March 6, 2025

RE: Arlington Garden Apartments-Binding Site Plan PLN # 1263 and  
Conditional Use Permit PLN # 1264 (the “Apartment Project”)

RE: Evaluations of Wetland and Fish and Wildlife Habitat Assessment Report (Parcel #31051000402700)

**WETLAND RATING FORM--FIGURE 1**  
COWARDIN PLANT CLASSES AMONG WETLAND  
UNINCORPORATED SNOHOMISH COUNTY  
TAX PARCEL NUMBER 31051000402600

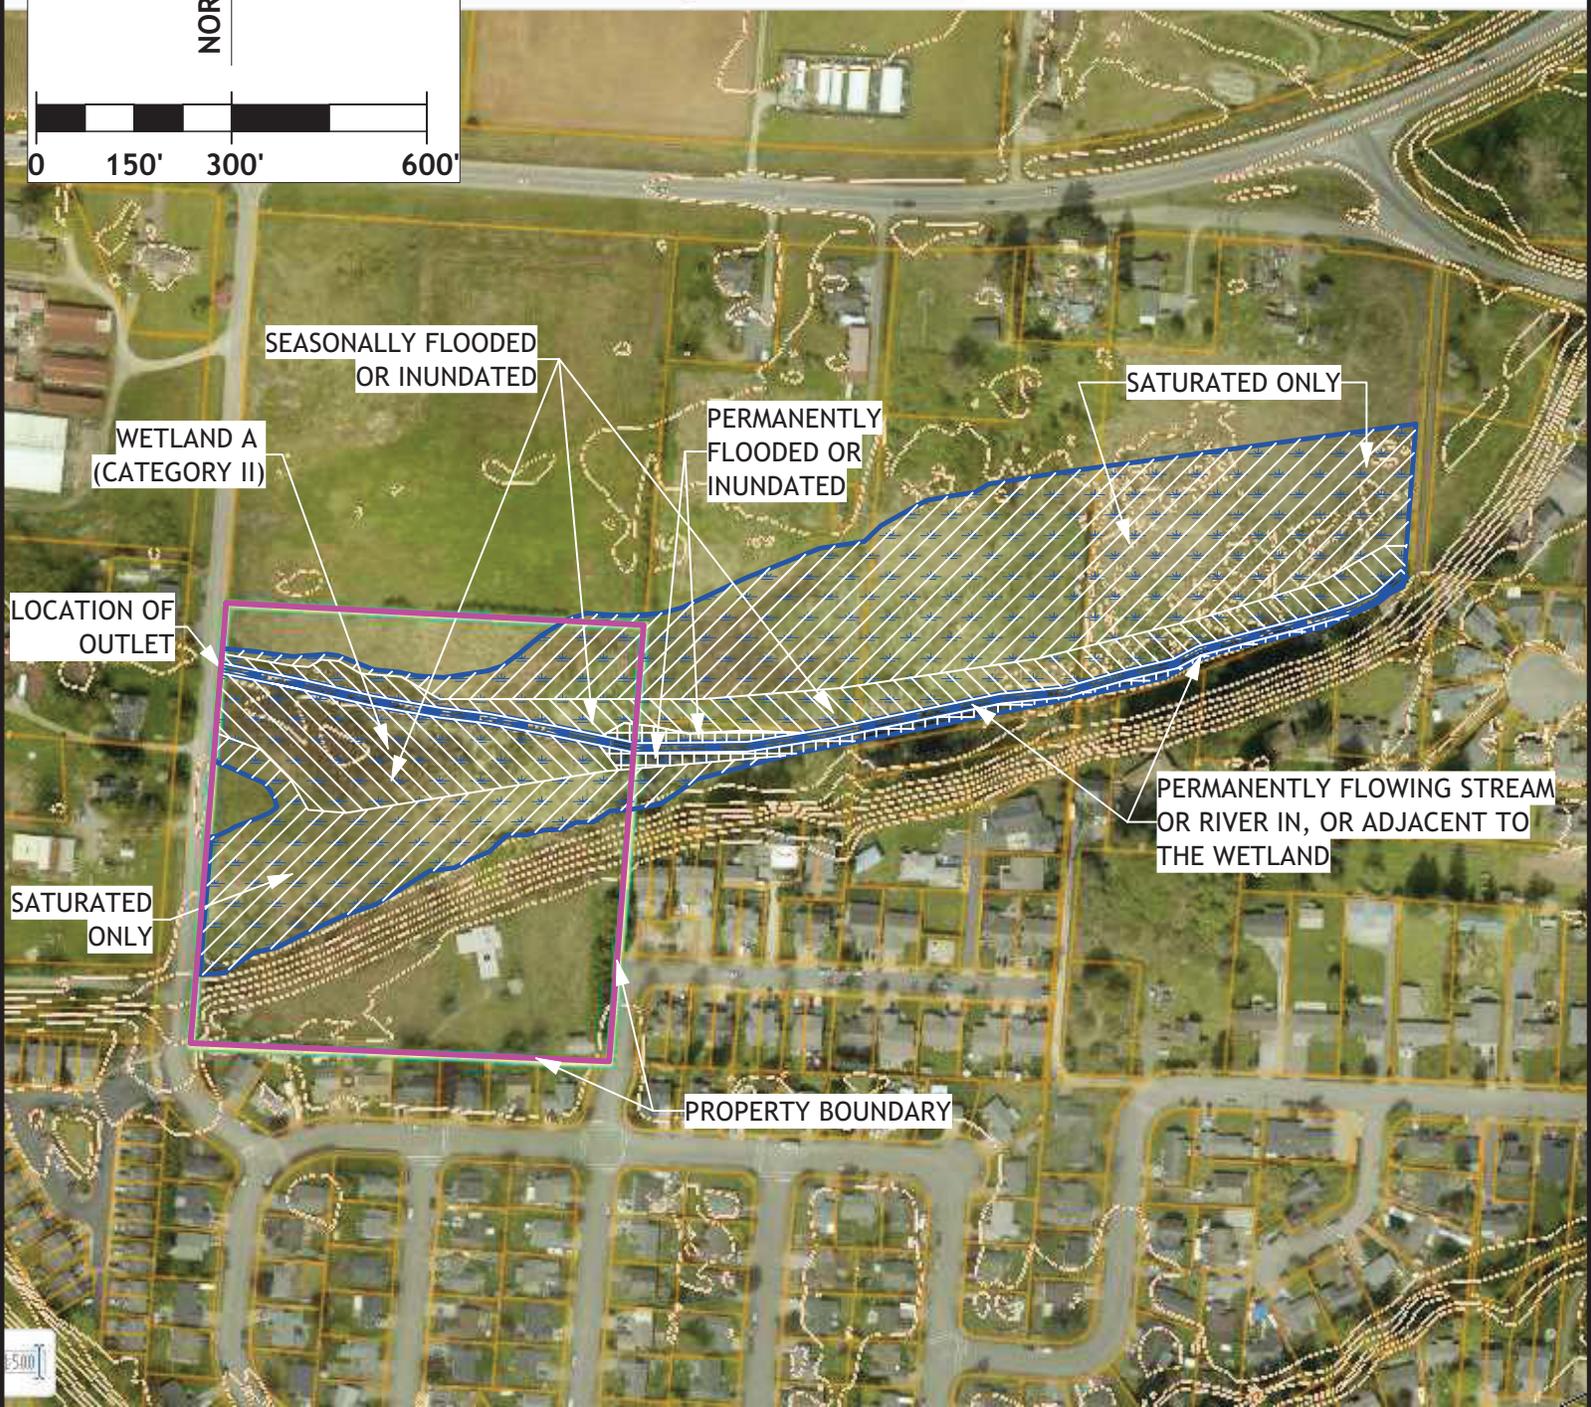
11. In my professional opinion, Question H1.1 on the Wetland Rating Form prepared and submitted by *Soundview Consultants, LLC* is also not accurate. The subject wetland includes emergent and scrub-shrub Cowardin vegetation classes. The rating form figure (Figure No. 1 of 5) that *Soundview Consultants, LLC* attached to their report differs from how they scored this question on the Wetland Rating Form. I don't think that the wetland rating unit contains a forested class across 15% of the wetland (as shown in the Wetland Rating Form Figures prepared by *Soundview Consultants, LLC*), but there is definitely a scrub-shrub class that exceeds the thresholds listed in questions H1.1. The number of points assigned on the Wetland Rating Form prepared and submitted by *Soundview Consultants, LLC* does not match their own figure which is Figure No. 1 of 5. That would increase the number points on that question from 0 to 1 (or from 0 to 2 points if they include a Forested vegetative class as depicted on their Figure No. 1 of 5). Either way, the point total for Question H1.1 is not accurate as 0 points as shown on the Wetland Rating Form prepared and submitted by *Soundview Consultants, LLC*.

**MAP SHEET: CA 1.00**

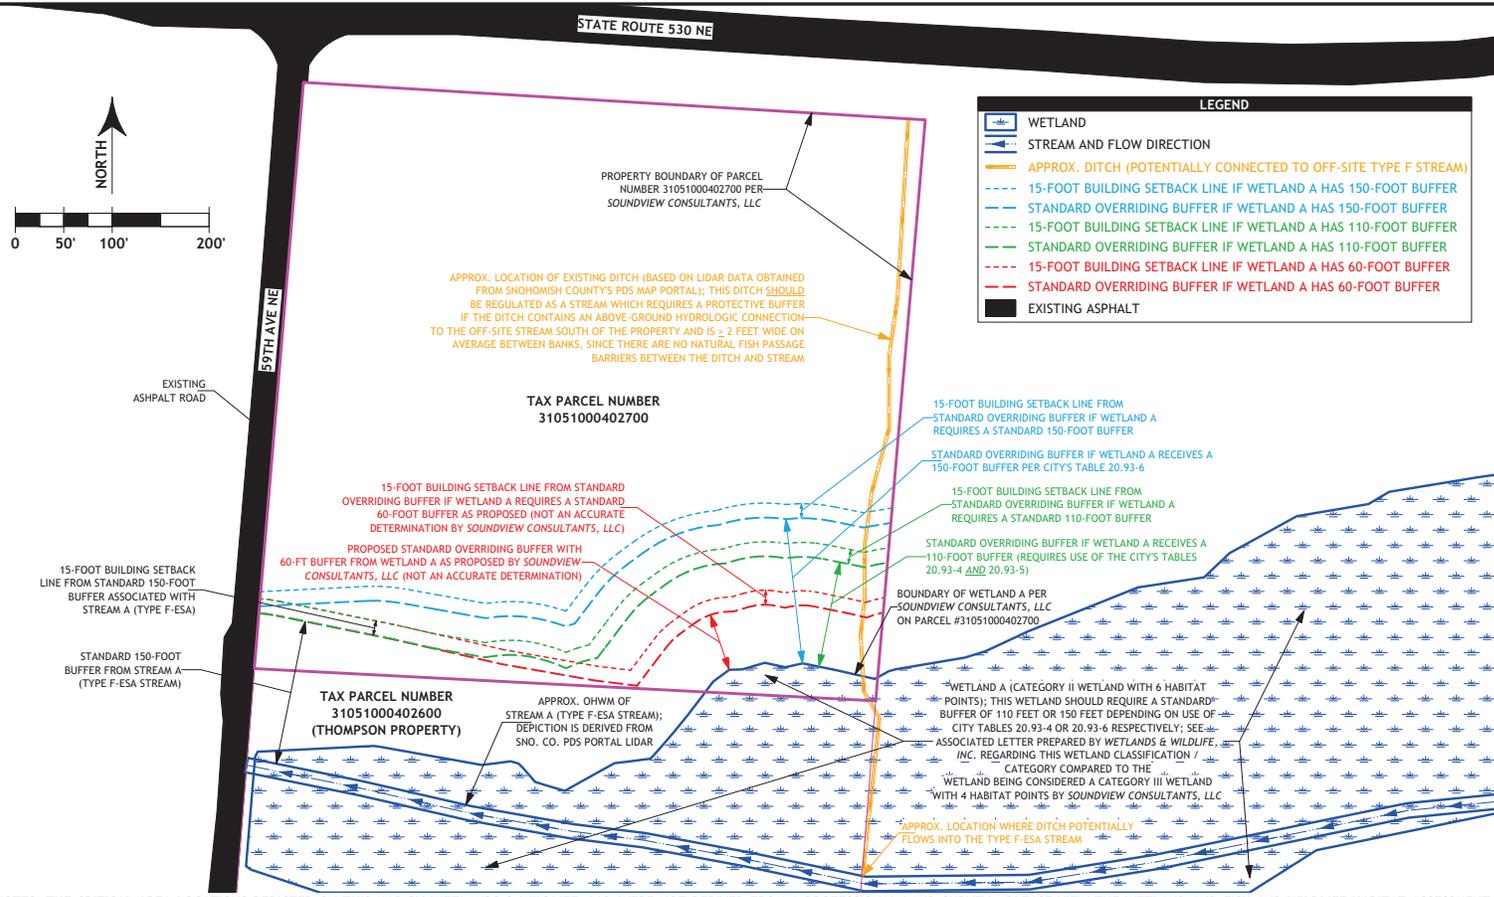
4. Please see the attached Map Sheet CA1.00 for the approximate location of a ditch located near the eastern property line of tax parcel number 31051000402700. This ditch is discussed on Page 9 of the Wetland and Fish and Wildlife Habitat Assessment Report dated July 2024 prepared by *Soundview Consultants, LLC*. It is my professional opinion that the City of Arlington should conduct detailed evaluations of that ditch to determine whether the ditch has an above-ground hydrological connection to the known fish-bearing stream (Type F-ESA stream) located on tax parcel number 31051000402600 (the Reidar Thompson property). If that ditch maintains an above-ground hydrologic connection to the Type F-ESA stream and is 2-3 feet wide as stated in the report prepared by *Soundview Consultants, LLC*, then the ditch should be regulated as a stream due to its connection to the Type F-ESA stream (even if the ditch is man-made). Washington Administrative Code (WAC) section 222-16-031 provides criteria for presumed fish-bearing waters. If the ditch is regulated as a stream per the City's Critical Areas Regulations, then a buffer would likely be required to extend from the Ordinary High Water Mark (OHWM) of that ditch as well. As previously noted, we don't have access to the ditch on parcel number 31051000402700 to make those determinations, but the appropriate City staff should closely evaluate the ditch to determine if the ditch meets the presumption criteria listed in WAC section 222-16-031.

19. Please see the attached Map Sheet CA1.00 prepared by *Wetlands & Wildlife, Inc.* which depicts the information discussed in this letter.
